**King County**

## **ENVIRONMENTAL CHECKLIST ADDENDUM**

### **PORTER REACH RESTORATION PROJECT**

May 2016, **Amended December 2016**

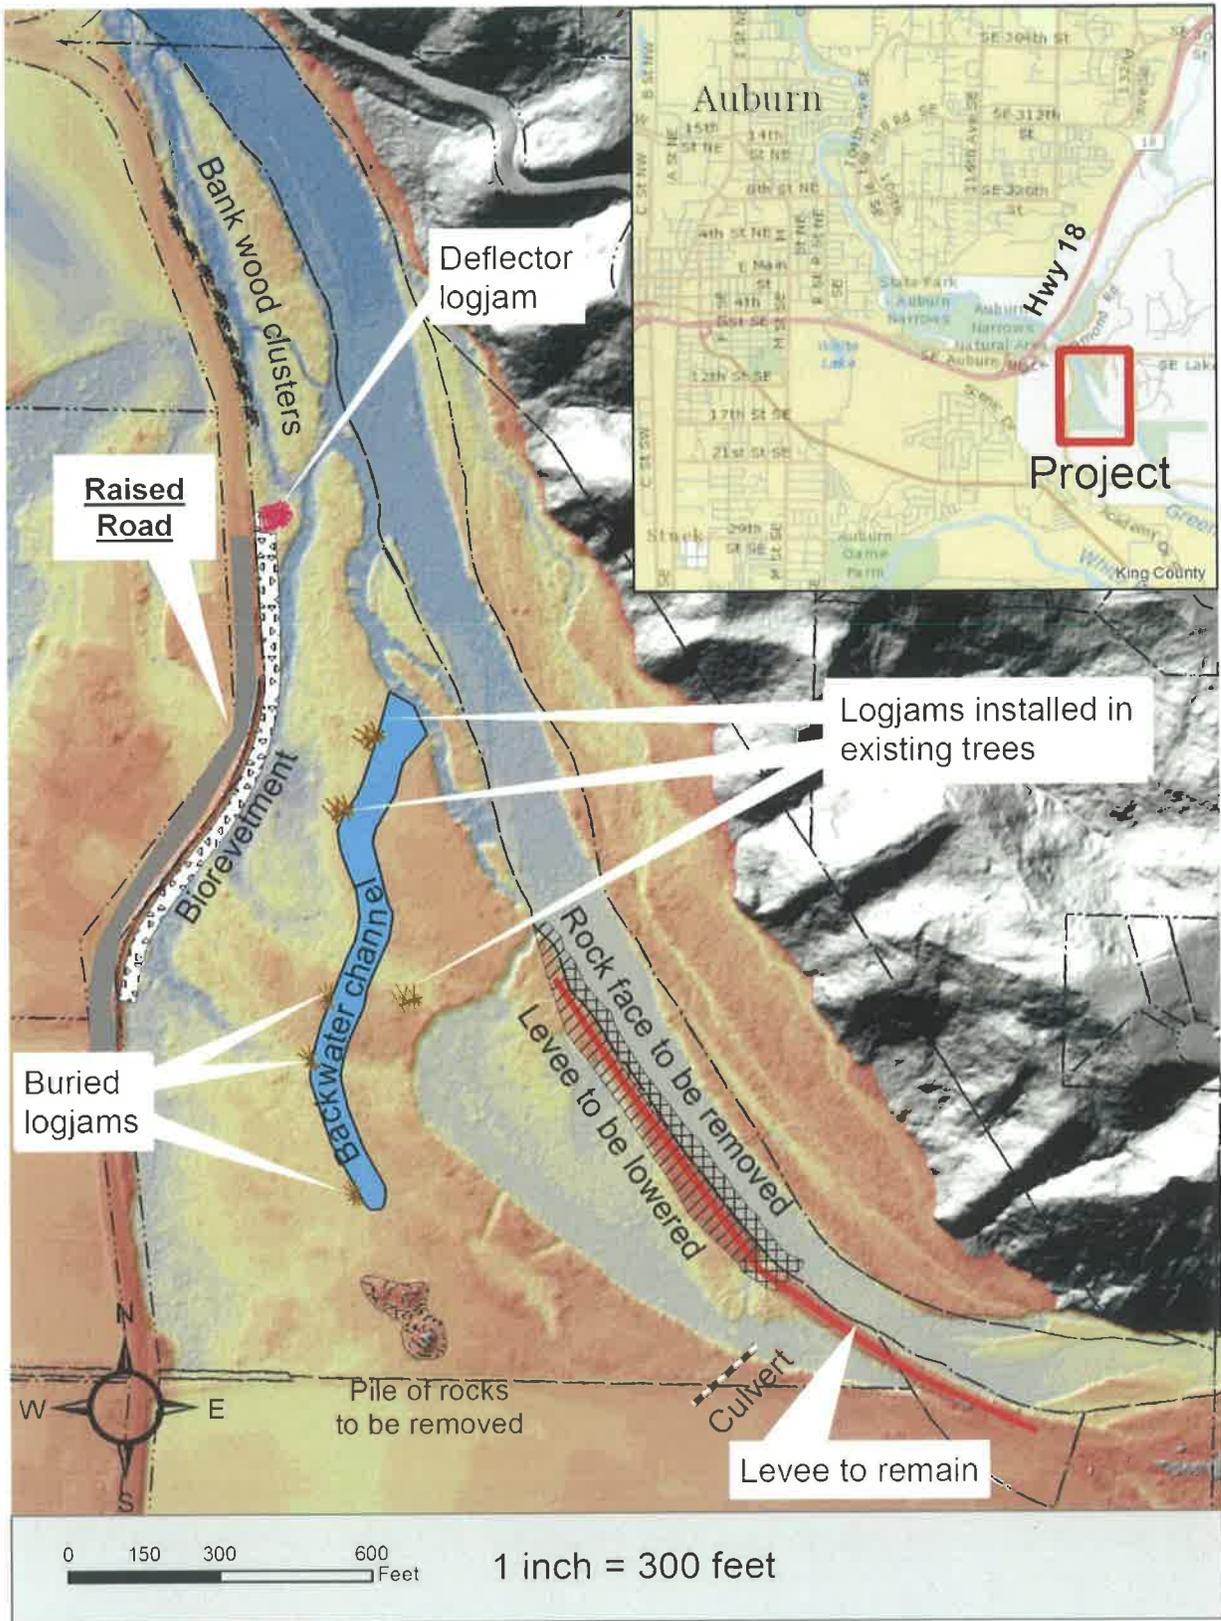
Project features include removal of the existing levee, construction of a biorevetment **including a raised road section**, logjam installation, backwater channel construction, placement of bank wood clusters, and removal of an existing rockpile (Figure 2).
